## NINE MILE POINT NUCLEAR STATION

**SUBJECT:** Nine Mile Point Nuclear Station  
Unit No. 2; Docket No. 50-410

Response to Request for Additional Information Regarding Nine Mile Point Nuclear Station, Unit No. 2 – Re: The License Amendment Request for Extended Power Uprate Operation (TAC No. ME1476) – Anticipated Transient Without Scram Simulator Tests and Net Positive Suction Head for Emergency Core Cooling Systems

**RESPONSE TO REQUEST FOR ADDITIONAL INFORMATION  
REGARDING LICENSE AMENDMENT REQUEST FOR EXTENDED  
POWER UPRATE OPERATION**

Figure 55  
Transient Test EPU Isolated ATWS MELLLA

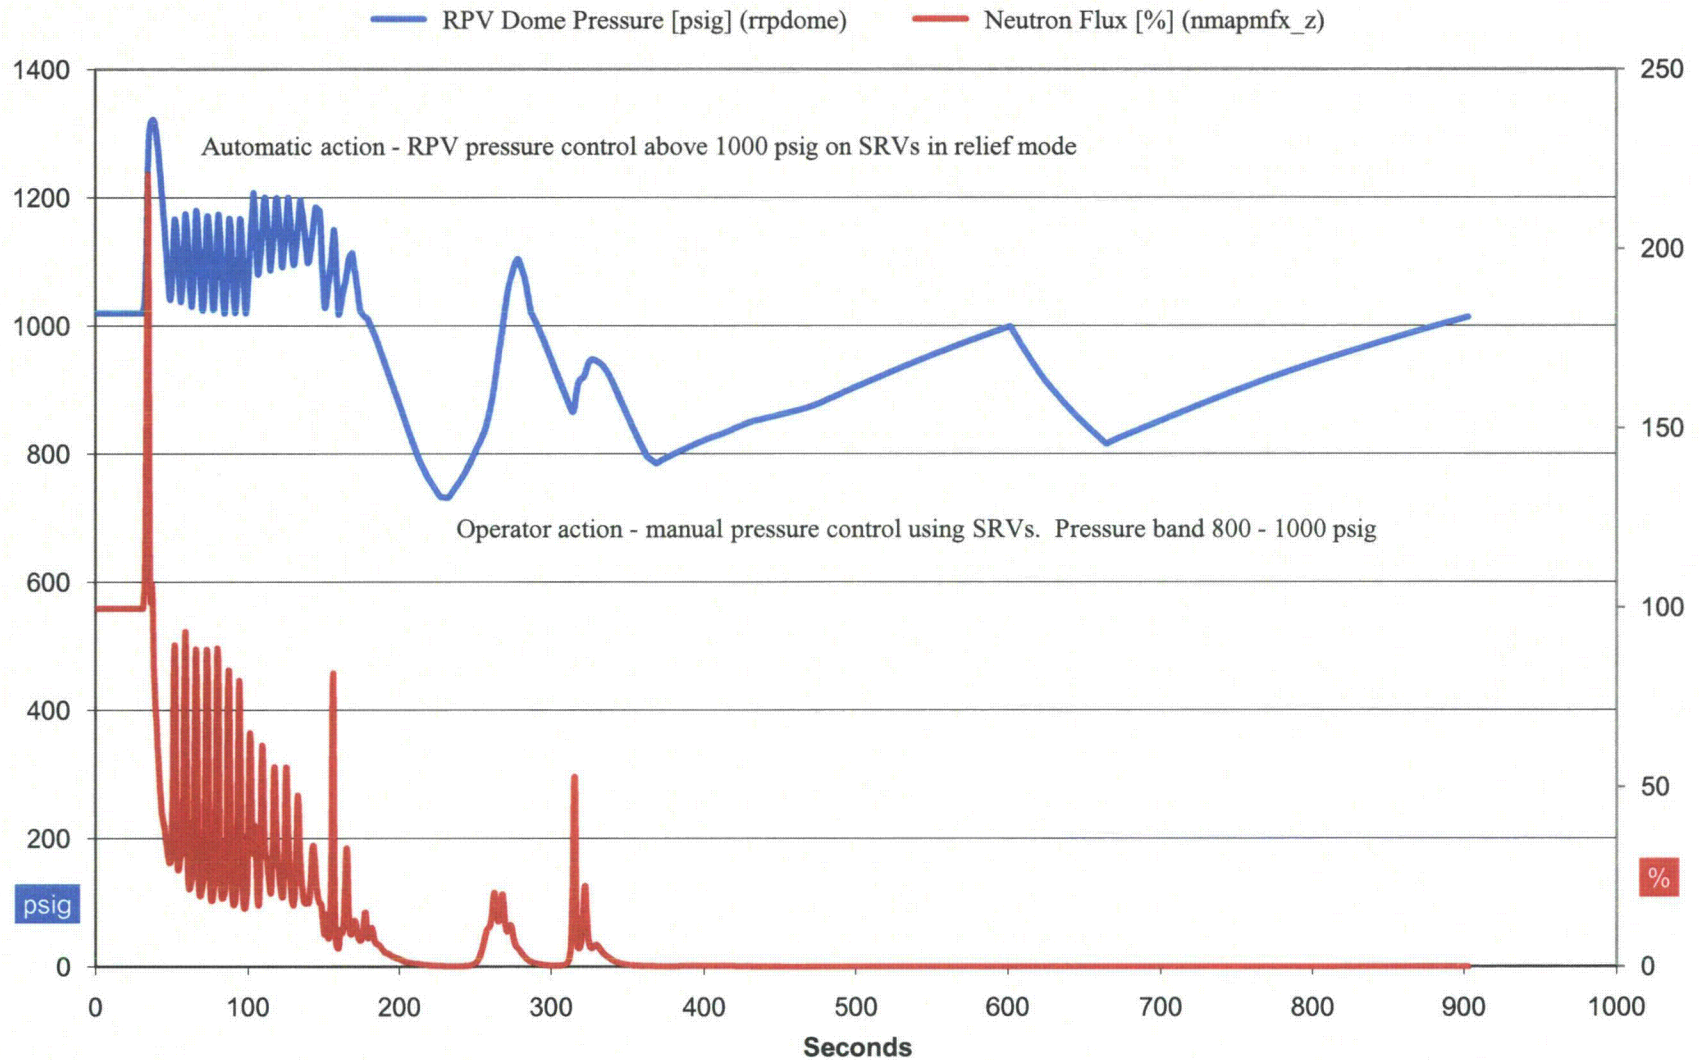
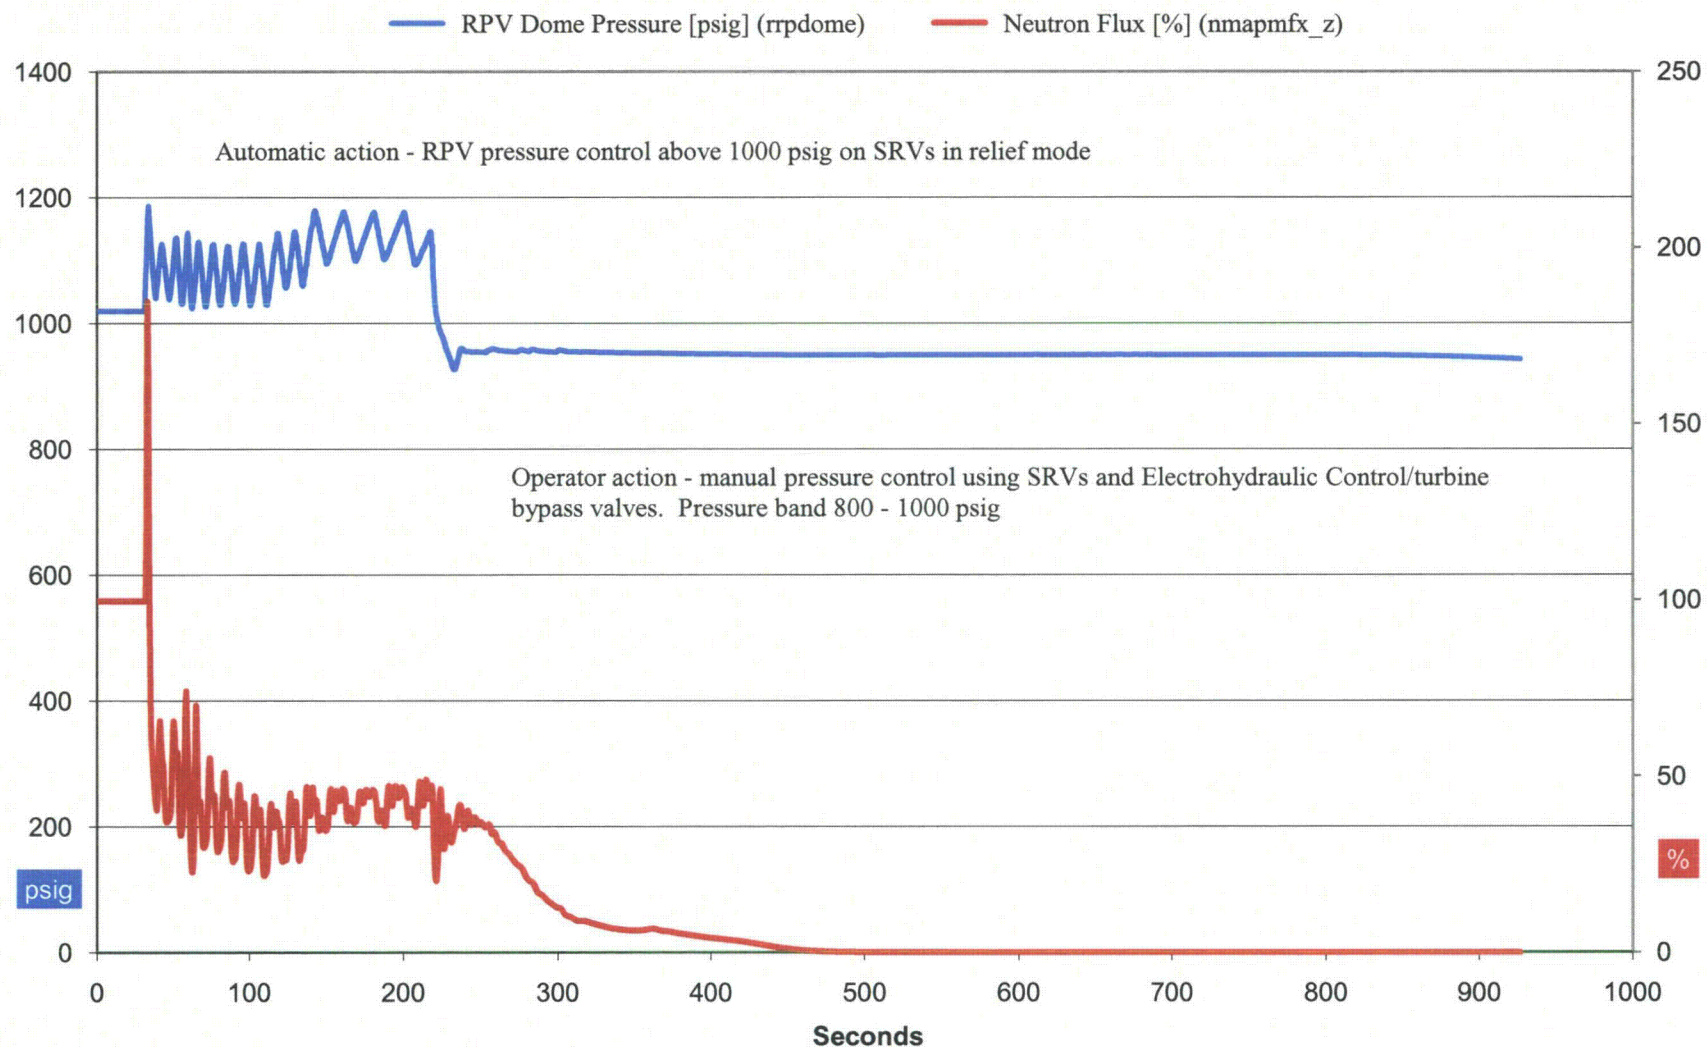
- 1) Provide the sequence of both events with the transient response(s) corresponding to ATWS emergency operating procedure actions (e.g., turbine trips, recirculation pump trips, turbine bypass valves open, power increases, water level reduction, standby liquid control system injection, to steady state/oscillation under control, etc.)*
- 2) For clarity of the data tables for both the MSIV closure and turbine trip ATWS EPU events, provide the full name/nomenclature with description or definition of each column field (e.g., rrp dome, nmapmfx\_z, fws1a101, etc.).*
- 3) In addition to the [Reactor Pressure Vessel] RPV Pressure vs. Time plots in both events, please include an overlay plot of Power versus Time (i.e., show power oscillations/response corresponding to the RPV pressure response).*

Figures 55 and 56 provide overlay plots that show RPV pressure and reactor power versus time for both of the ATWS Simulator exercises.

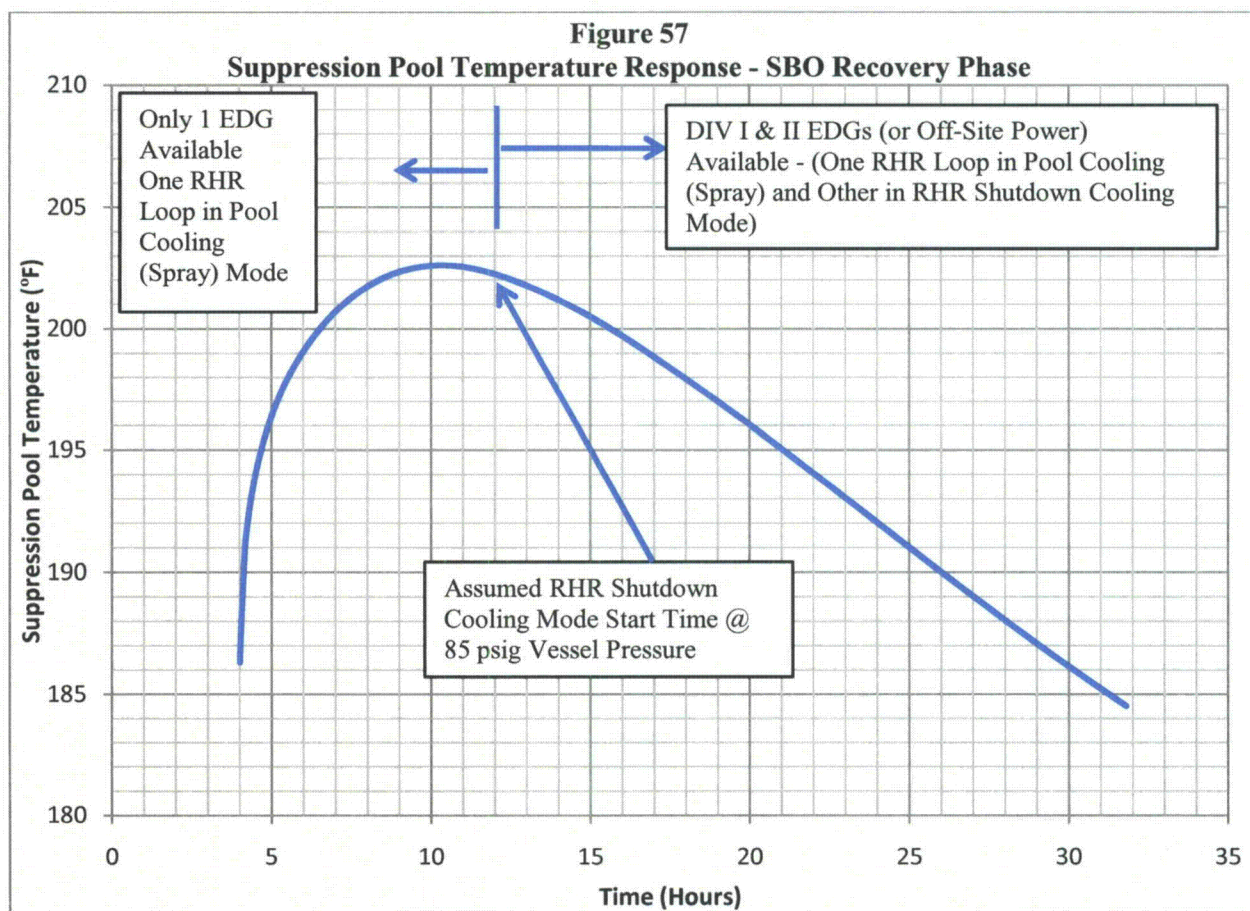
*The technical staff requests additional clarification in NMPNS' RAI response dated May 9, 2011, regarding the operation of the pumps during [a] SBO, particularly after the coping period. The RAI response stated that the SBO scenario was not included in the licensee's evaluation as the [Reactor Core Isolation Cooling] RCIC pump is relied upon during the coping period. Nothing was said in the response about operation of other pumps past the SBO coping period.*

source is the Condensate Storage Tank (CST). During SBO recovery, no debris loading on the strainer is assumed. Thus, for SBO recovery, the margin is defined based on the ASDC event margin plus 2 feet of head, which results in a minimum NPSH margin ratio above 1.6 when the suppression pool is at 212°F.

With the assumptions noted above, a simple suppression pool heatup estimate is shown in Figure 57. The suppression pool temperature increases over a two to three hour period to above 200°F, but is predicted to remain below 208°F for the duration of the recovery period. The reactor pressure is reduced below the assumed 85 psig after approximately 12 hours from SBO initiation (8 hours after the initial 4-hour coping period). Consistent with the ASDC assumptions, the 1.6 margin ratio is maintained with suppression pool temperature below 208°F. Therefore, the 1.6 margin ratio is maintained assuming no containment accident pressure and conservatively assuming no credit for the increased suppression pool level predicted for SBO during the recovery phase with RCIC taking suction from the CST.

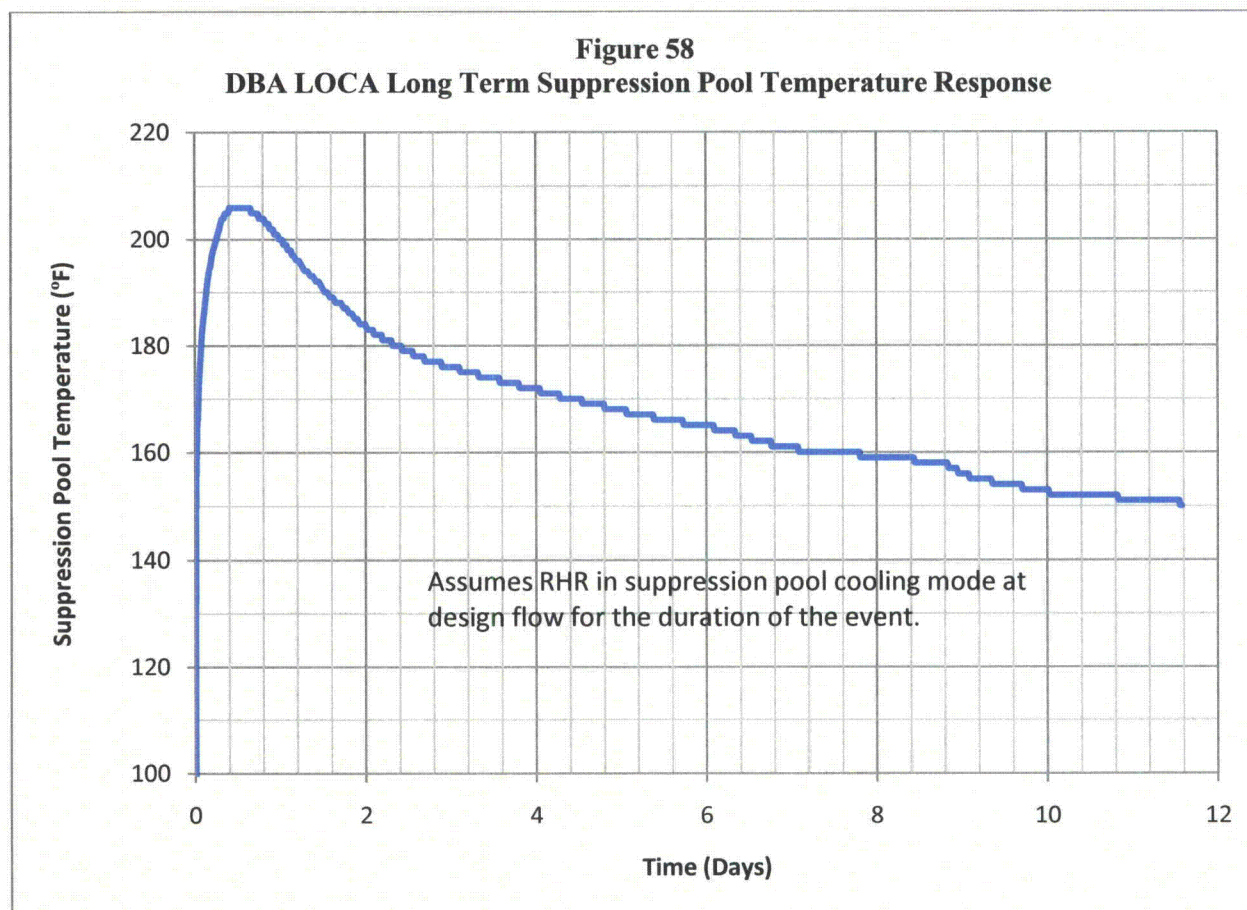
*In letter dated May 9, 2011, it was stated that the [Low Pressure Coolant Injection] LPCI ([Residual Heat Removal] RHR) pumps could operate at margin ratio of less than 1.6 for approximately 839 minutes (~14 hours) for [Design Basis Accident – Loss of Coolant Accident] DBA-LOCA and 376 minutes (~6.3 hours) for [Alternate Shutdown Cooling] ASDC. It was further stated that the operational times were based on the tabular values for suppression pool temperature versus time developed to generate the graphs in NMP2 EPU LAR dated May 27, 2009. However, the graphs that were included in the EPU LAR only go up to  $10^5$  seconds (~28 hours). It is not clear how long a period did NMPNS evaluate the operation of the pumps. During long-term cool-down, the pumps could operate at a flow rate higher than during short-term, thus potentially reducing [Net Positive Suction Head] NPSHA. Please provide additional information to assure the staff that NMPNS has considered all factors that could potentially affect the margin ratio during long-term cooling in arriving at the above mentioned times.*

Figures 58 and 59 provide the long term suppression pool temperature versus time for the DBA-LOCA and ASDC scenarios. The evaluated time periods for the DBA-LOCA and ASDC scenarios are approximately 12 days and approximately 2.5 days, respectively. Both scenarios assume that the RHR pumps are operating at the design basis suppression pool cooling flow rate for the duration of the event. The NPSH margin assessment conservatively applied the design basis runout flow assumption.

For the DBA-LOCA and ASDC scenarios, the NPSH margin ratios are above 1.6 for suppression pool temperatures below 202°F and 208°F, respectively. (Note: The difference in maximum temperatures is due to assuming a debris loading on the strainer for the DBA-LOCA case and assuming no debris loading on the strainer for the ASDC case.)
